HISTORIC AND DESIGN REVIEW COMMISSION

June 21, 2017

HDRC CASE NO: 2017-293
ADDRESS: 1918 W MAGNOLIA AVE
LEGAL DESCRIPTION: NCB 1961 BLK 9 LOT 22
ZONING: R-6 H
CITY COUNCIL DIST.: 7
DISTRICT: Monticello Park Historic District
APPLICANT: Bob Bradley
OWNER: Emily Gorman
TYPE OF WORK: Extension of front porch, installation of new porch decking
REQUEST:

1918 W. MAG. / NEW ROOF FOR
EXISTING FRONT PORCH

ELEVATION OF PROPOSED PORCH ROOF

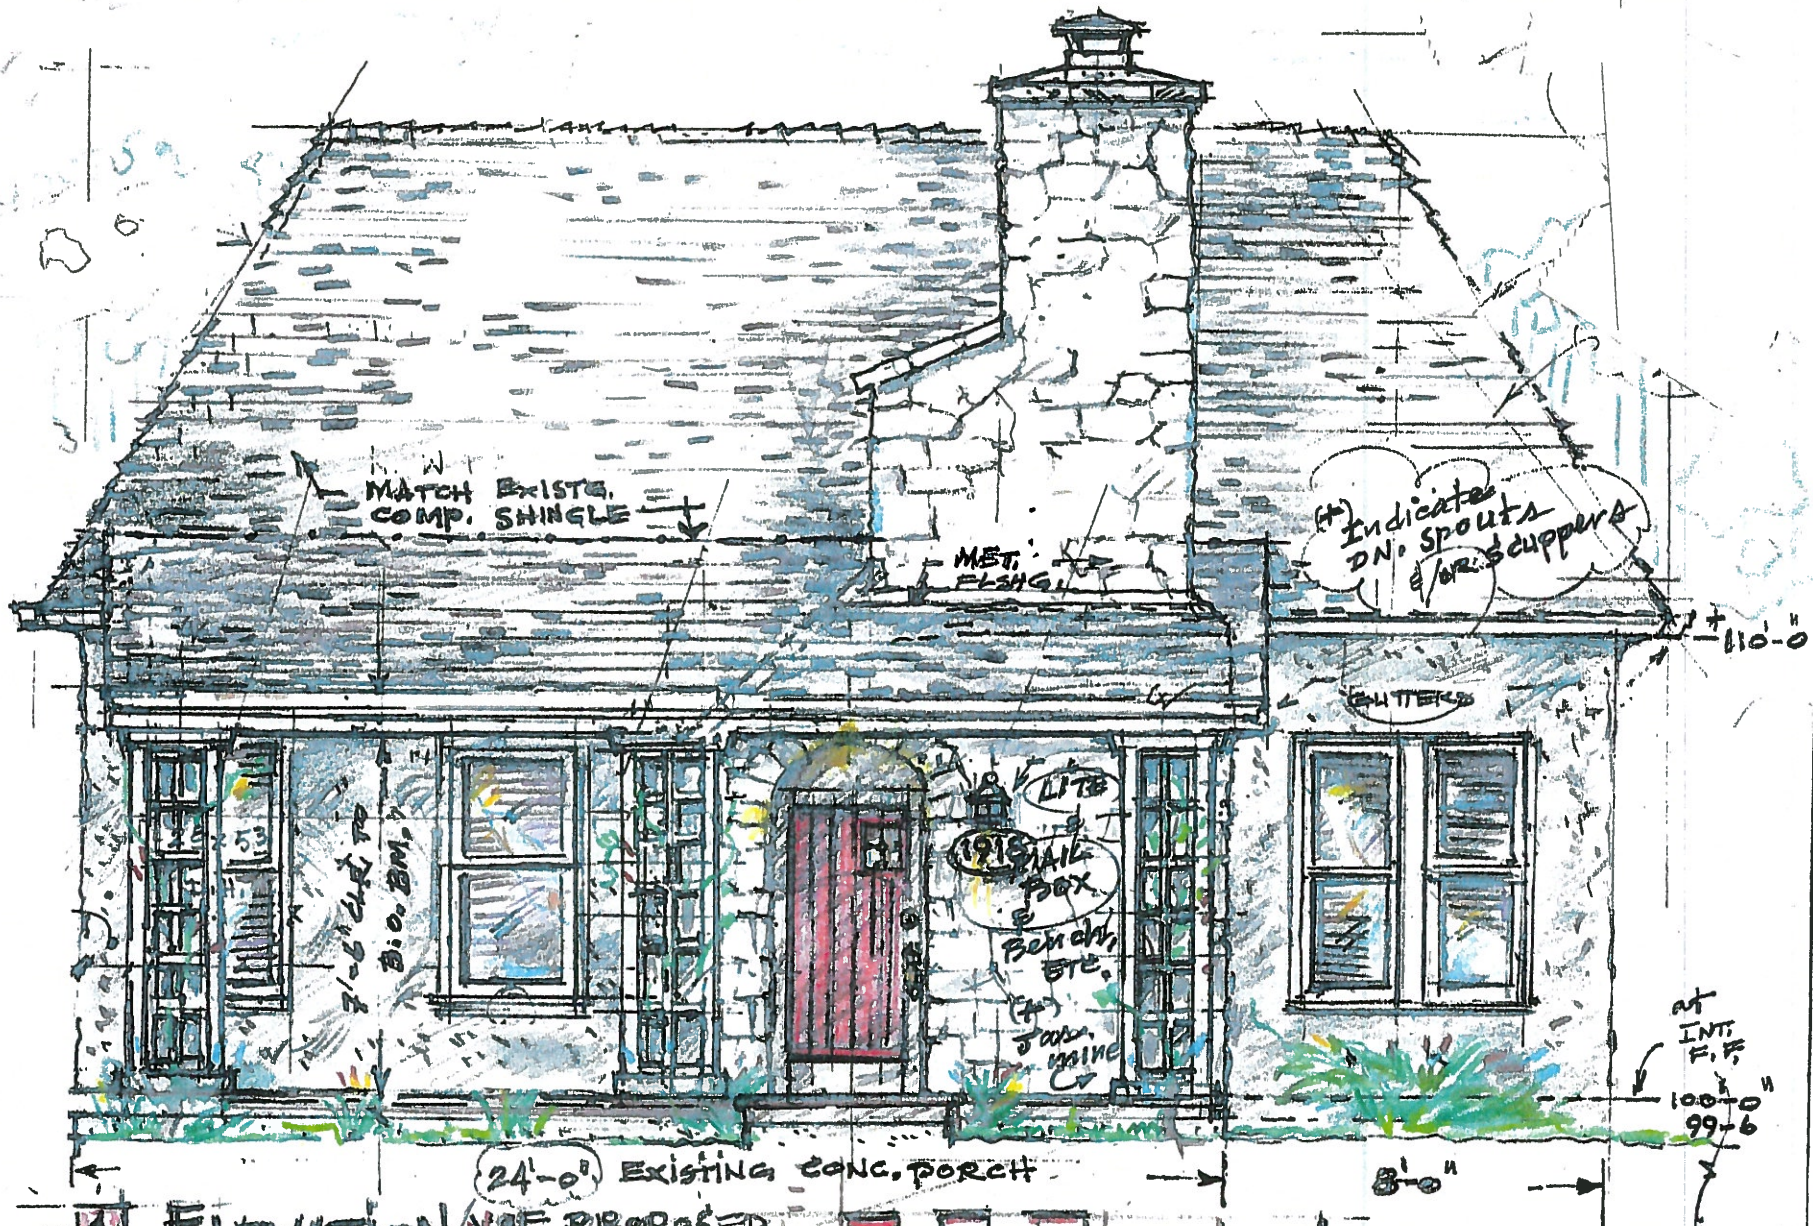
- b. **FRONT PORCH** – The applicant has proposed to install a new roof that extends the front roofline to create a new front porch. The porch will extend the width and length of the existing concrete decking, which measures approximately 8 feet by 24 feet. The new roof will have a pitch of approximately 4:12 and will be covered with composition shingles to match the existing material of the primary structure's roof. The new porch roof will be supported by pairs of painted wood columns measuring 4x4" with a trellis constructed with 2x2" painted wood beams. The trellis will be covered with flowering jasmine. According to Guideline 7.A.i, new porches should not be added where historically present. There is no evidence that a front porch historically existed on this structure, and a front porch configuration similar to the proposed submission is not characteristic of Tudor homes of this scale and configuration. Additionally, the proposed porch will partially conceal the front chimney, which is a character defining feature of the home. Staff does not find the proposal consistent with the guidelines as submitted.

Staff does not recommend approval as submitted based on findings a through c.

SECTION "A" - THRU PROPOSED PORCH ROOF
LOOKING WEST
1/2" = 1'-0"

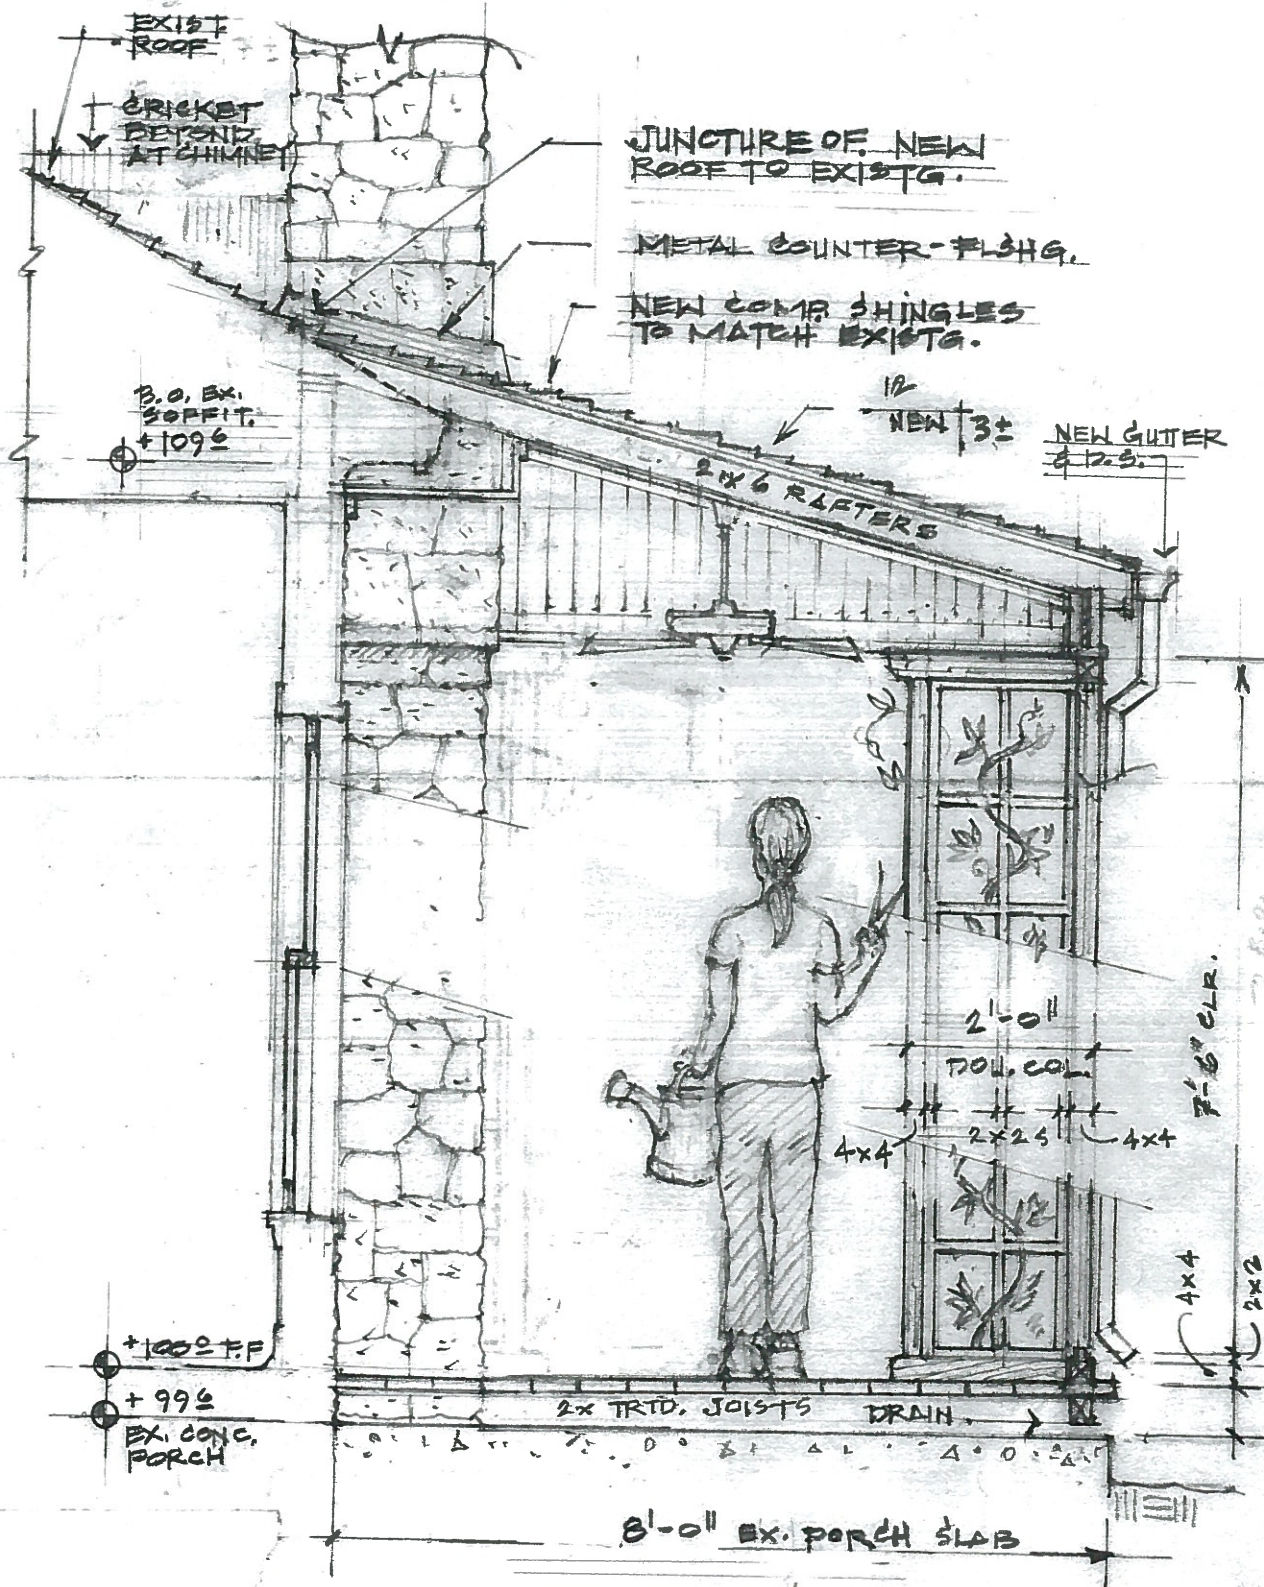
- c. **WOODEN DECKING** – The applicant has proposed to cover the existing concrete decking slab, measuring approximately 8 feet by 24 feet, with new treated wood decking. The decking will extend the existing depth of the deck to provide an adequate level landing with the front door. The decking will be slightly raised from the concrete slab. According to Guideline 7.A.iii, original concrete porch floors should be preserved, and covering them with other materials should be avoided unless they were used historically. Staff does not find the proposal consistent with the Guidelines.
